FHWA REGION NO.	STATE	PROJECT NO.	YEAR	SHEET NO.	TOTAL SHEETS
7	KANSAS	54-87 K-6657-01	2002	658R	1122

ADDENDUM NO. 2:
The following changes and additions shall be made to the plans and proposal. When this addendum conflicts with the specifications, plans, or special provisions or Addendum No. 1, THIS ADDENDUM SHALL GOVERN.

TRAFFIC SIGNAL PLAN
KELLOGG & MAIZE ROAD
WIRING DIAGRAM

658R

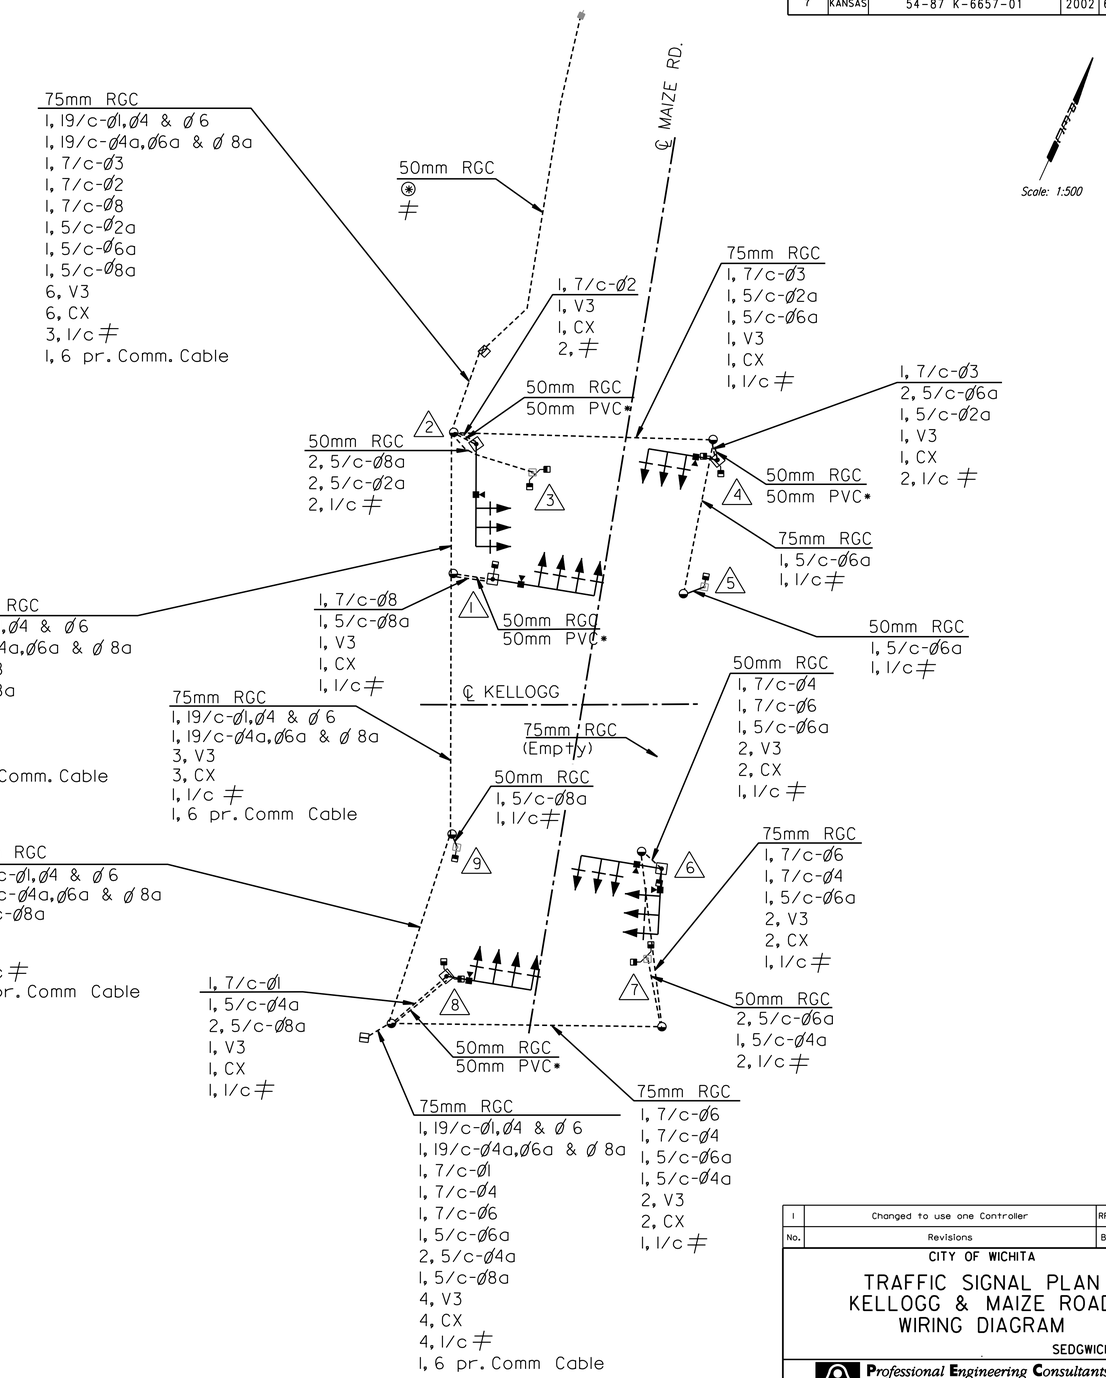
Sheet 658R
1. Add a single 50 mm PVC conduit from the Service Box at Sta. 15+598, 13 m Lt. to the Service Box at Sta. 15+644, 11 m Lt.
